TO: CITY OF NOVI PLANNING COMMISSION
FROM: LINDSAY BELL, AICP, SENIOR PLANNER
THROUGH: BARBARA MCBETH, AICP, CITY PLANNER
SUBJECT: JSP 17-69 EBERSPAECHER WAREHOUSE INFILL -
PRELIMINARY SITE PLAN APPROVAL EXTENSION
DATE: FEBRUARY 20, 2020

EBERSPAECHER WAREHOUSE INFILL PROJECT JSP17-69

PLAN REVIEW CENTER REPORT

JSP 17-69

NOV JOB NO. SHEET NO.
J669 L1

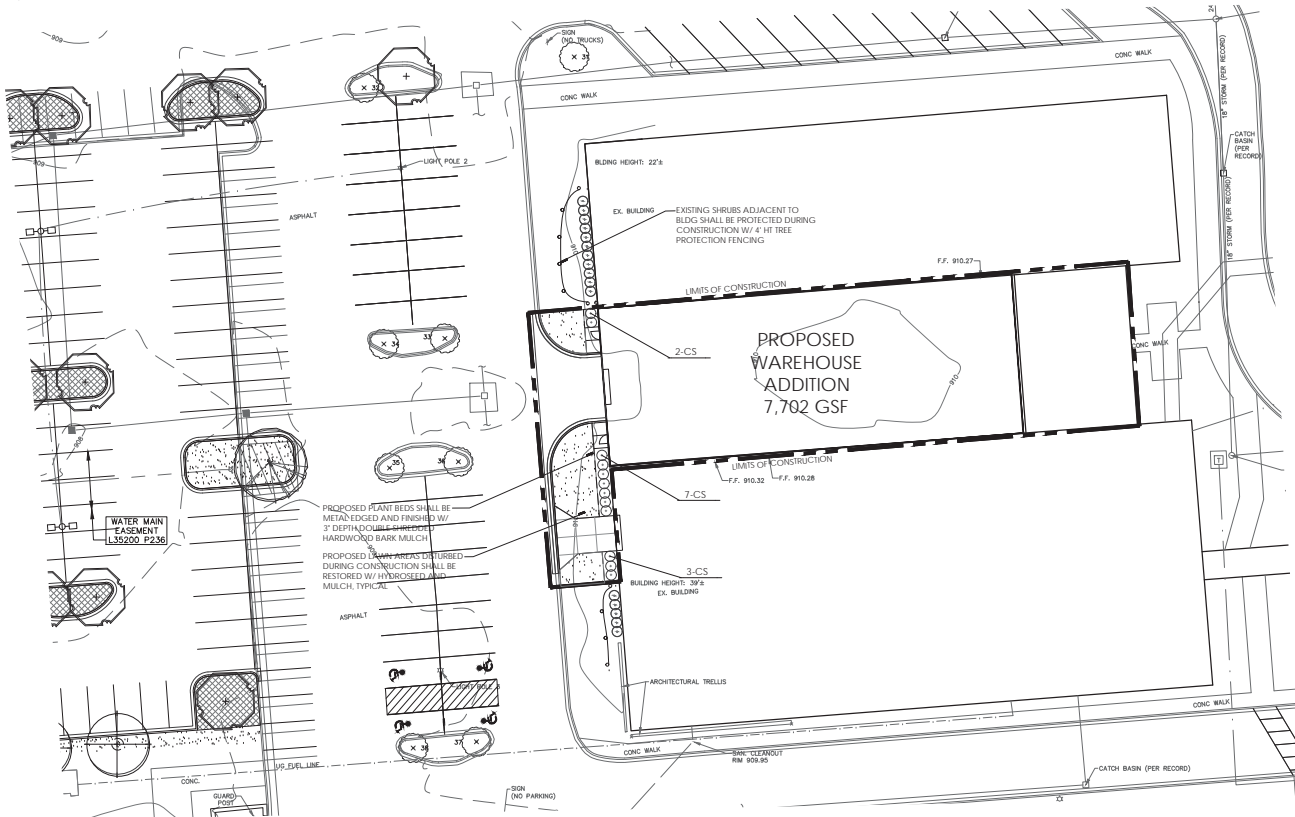
1. **Please revise Note #7 regarding replacement of failed plant material to 3 months instead of 1 year.**
2. **Please copy the landscaping costs provided separately to Sheet L1.**

1. Final Stamping Sets shall reflect a revision to Note #7 regarding replacement of failed plant material to 3 months in lieu of 1 year.
2. The landscape estimate will be added to sheet L1.
